Evaluation of Physical Barriers – West Corona Station

Address: 155 Auto Center Dr, Corona, CA 92880

Evaluation Date: 07-27-2021

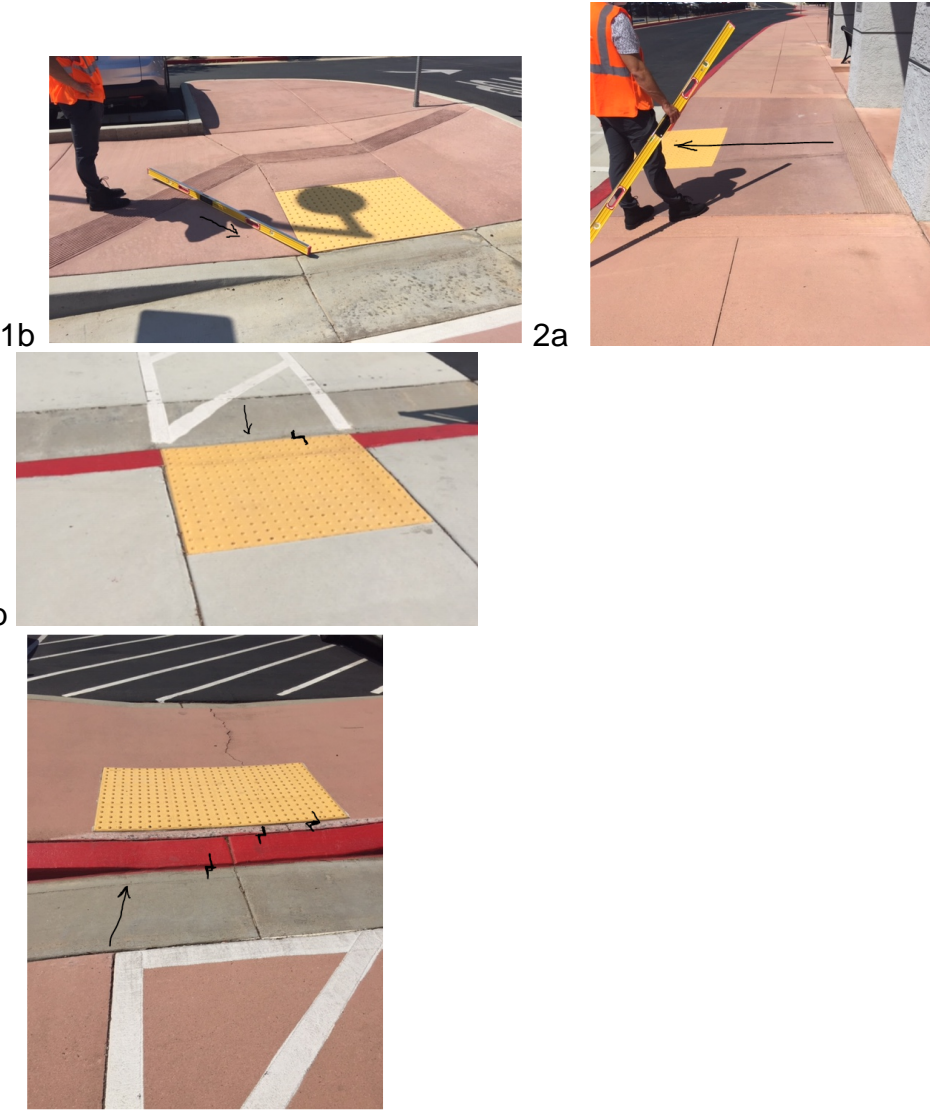
1. Curb ramps (1a-1b, 1c, 2a-2b, 3a-3b, 4a-4b, 4c, 5a, 5b, 6a, 7a, 7b)
2. Pedestrian road crossings
 - a. Pedestrian push button signals (where applicable)
3. Accessible routes
 - a. Walking surfaces
 - b. Elevators
 - c. Pedestrian Bridge
 - d. Stairs
 - e. Ramps
4. Platforms
 - a. Walking surfaces
 - b. Mini High platforms and ramps
5. Pedestrian rail crossings
6. Access to public amenities
 - a. Ticket Vending/validation machines (TVM),
 - b. Benches,
 - c. Trash cans,
 - d. Drinking fountain
 - e. Communication Systems- passenger information phones, blue emergency phones, yellow call boxes, service phones, emergency phones.
 - f. Vending machines
7. Accessible parking spaces
8. Bus stops
9. Signage
10. Public Address Systems
11. Staff facilities
 - a. Security Staff Facility
 - b. Dumpster

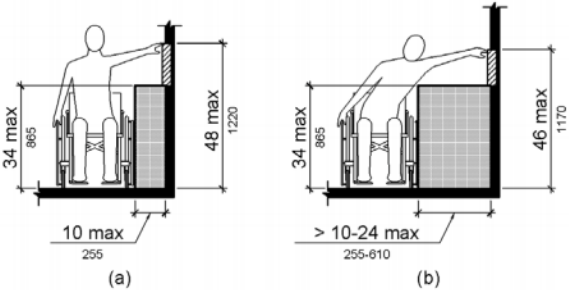
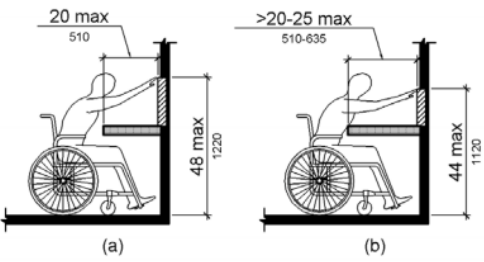
Issues/Barriers Identified	Recommendations	Comments
2. Pedestrian Road crossings Pedestrian crossing at 3a, 3b has multiple cracks and gaps in excess of ½” wide and ¼” deep. 	<p>Examine all pedestrian crossings and repair all cracks.</p> <p>Every joint in concrete deeper than ¼” and wider than ½” shall be filled.</p> <p>Every level change along the accessible route greater than ¼” and less than ½” height needs to be beveled (1:2) slope or repaired.</p> <p>Every level change greater than ½” needs to have a ramped surface (1:12) slope.</p>	See item 3a
a) Pedestrian Push Button- Not Applicable	No action by RCTC

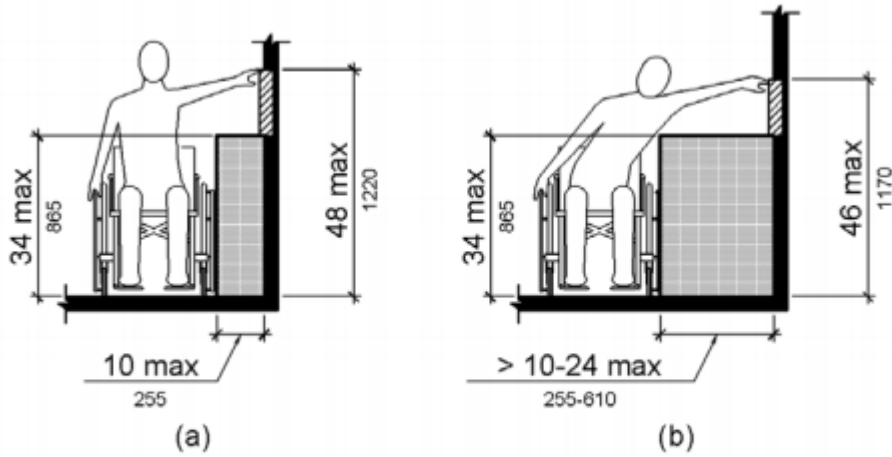
Issues/Barriers Identified	Recommendations	Comments
3. Accessible Routes		
a) Walking surface		
<p>i. From curb ramp 5a, a sidewalk entering the facility is provided. The slope of the sidewalk is measured as 9.6% which matches the grade of the road but exceeds the maximum allowed slope for accessible ramps.</p> <p>ii. A vehicular ramp into the gated areas is perpendicular to the sidewalk described above. This causes a steep drop and excessive cross slope for the already steeply sloping sidewalk.</p> <p>iii. General: There are uneven joints and cracks observed in the concrete on the platforms and along accessible route. Sealant/filler in some deep joints is missing. This causes trip hazards and creates openings deeper than ¼” and wider than ½ inch that do not comply with 302.3 and 303.3. (Figure on previous page)</p> <p>iv. Manhole covers create trip hazards and have gaps/openings wider than ½ inch.</p> <p>v. Signage designating the accessible route is missing at main entry.</p>	<p>i) The grade of the sidewalk along the road complies with the requirements of City of Corona, DIB-82-06 and PROWAG if the ramp is considered a public street. If the ramp is considered to be an entry to private property, then these requirements are not applicable, and this ramp is considered out of compliance.</p> <p>RCTC being a public agency, it can be assumed that the commuter rail stations owned by RCTC would be public property. It is recommended prior to initiating any repairs on the ramp, that this issue be reviewed by an ADA legal expert to determine final resolution.</p> <p>ii) Same as above. An alternate accessible route is required.</p> <p>iii) and iv) Repair all level changes. Close gaps and openings wider than ½” and deeper than ¼”, and remove trip hazards in the accessible route.</p> <p>v) Provide signage designating the accessible route.</p>	<div>  <p>Figure 302.3 Elongated Openings in Floor or Ground Surfaces</p> </div> <div>  <p>Figure 303.3 Beveled Change in Level</p> </div> <div>  <p>Figure 303.2 Vertical Change in Level</p> </div> <p>402.2 Components. Accessible routes shall consist of one or more of the following components: walking surfaces with a running slope not steeper than 1:20, doorways, ramps, curb ramps excluding the flared sides, elevators, and platform lifts. All components of an accessible route shall comply with the applicable requirements of Chapter 4.</p> <p>405.2 Slope. Ramp runs shall have a running slope not steeper than 1:12.</p> <p>405.8 Handrails. Ramp runs with a rise greater than 6 inches (150 mm) shall have handrails complying with 505.</p>

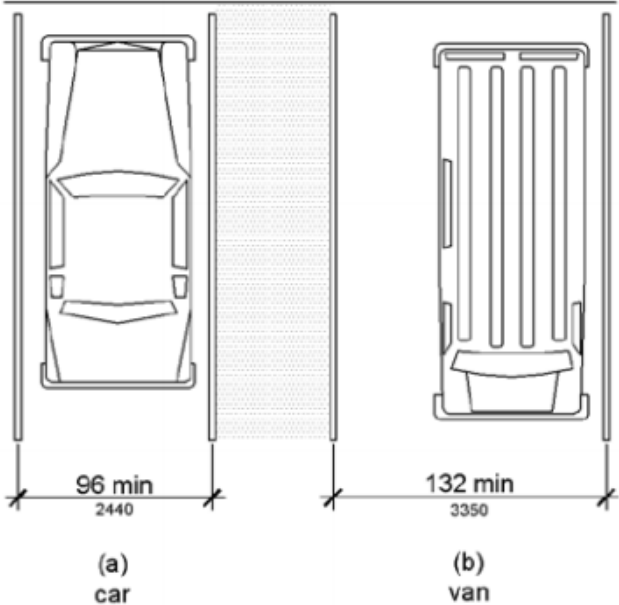
<div><div>ii. Downspouts protrudes in the accessible circulation path</div></div>	<div><div>Provide 48 inches wide accessible path with a compliant cross slope, clear of the downspout.</div></div>	<div><div></div><div>Figure 307.2 Limits of Protruding Objects</div><div>307.5 Required Clear Width. Protruding objects shall not reduce the clear width required for accessible routes.</div></div>
